**SYAMA PRASAD MOOKERJEE PORT,KOLKATA**  
**Formerly KOLKATA PORT TRUST**  
**HALDIA DOCK COMPLEX**

**Tender No. SDM(P&E)/T/ 74 /2020-2021**

**Design, Supply, Installation, Testing and Commissioning of 25 Nos. 30 Mtrs. high Hot Dip Galvanized High Mast Tower with LED fitting and replacement of LED luminaires on 40 Nos. existing 30 Mtrs. High Mast along with Comprehensive Maintenance Contract of 5 years at Haldia Dock Complex, SMP, Kolkata (Phase-II).**

**ADDENDUM - I**

KOLKATA PORT TRUST		NAME	DT
HALDIA DOCK COMPLEX		DGN.	
M(P&E)'S DRG.OFFICE		DRN.	30-08-10
SINGLE/MULTI NUMBERS H.T./L.T.		ICD.	
CABLES IN ONE TRENCH.		CKD.	
SCALE:-NTS		APD.	
DRG. NO. SK-334

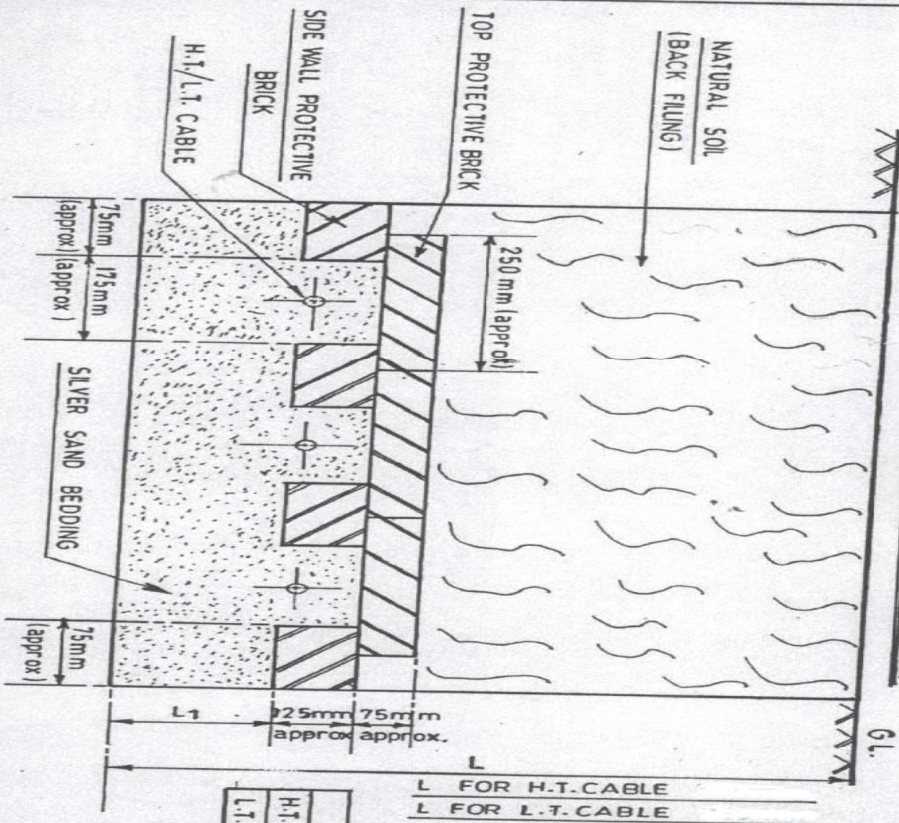
7.	58	5.5 Laying of cables	.....as shown in Drawing No.:SK-334	.....as shown in Drawing No.:SK-334 (attached as-Annexure-B)
8.	45	4.1 HT Panel	a)11 kV, 630A SF6 encapsulated VCB with self-tripping mechanism having external dc source with numerical relay with IDMT, over current, earth fault and Instantaneous protection including TVM.	a)11 kV, 630A SF6 encapsulated VCB with self-tripping mechanism with numerical relay with IDMT, over current, earth fault and Instantaneous protection including TVM. Self-Powered Relay, Ashida-make is also acceptable for use in RMU for O/C & E/F protection having Modbus Communication over RS 485 port.
